Environmental & Heritage Management

5 March 2021

COMMENTS ON THE MAINTENANCE MANAGEMENT PLAN FOR THE PROPOSED RESTORATION AND MAINTENANCE OF THE BLUE STONE QUARRY WALL, ROBBEN ISLAND (Feb 2021)

Figure 1: Activities proposed in Environmental Authorisation Reg14/12/16/3/3/1/747

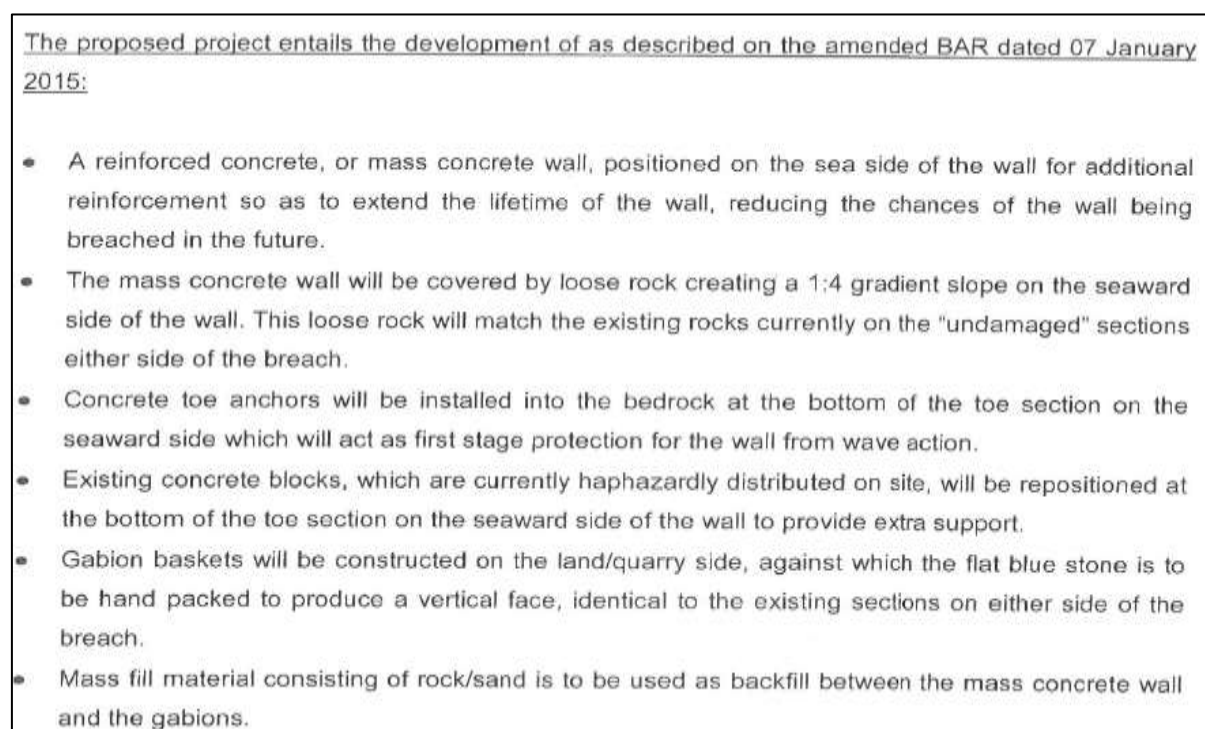
2.4 Activities authorised in 2015: When considering the scope of activities proposed and the scope of activities previously authorised, it is evident that the proposed construction activities differ from the construction activities previously authorised in the Environmental Authorisation Reg14/12/16/3/3/1/747. (See below figure 1). This is welcomed, as a more authentic and temporary structure is now proposed to be constructed in line with the original nature of the seawall.

2.5 Further authorisation required: Despite being preferable to what was authorised in 2015, this scope of work is not in line with the conditions contained in the environmental authorisation. The 'scope of authorisation' stipulated that the 'authorisation of the

activity was subject to the conditions contained in the authorisation, which formed part of the environmental authorisation, and which were binding on the holder of the authorisation'. Therefore, any changes to, or deviations from, the project description set out in the authorisation, would appear to require further authorisation in terms of the regulations, if the Department deems it necessary.
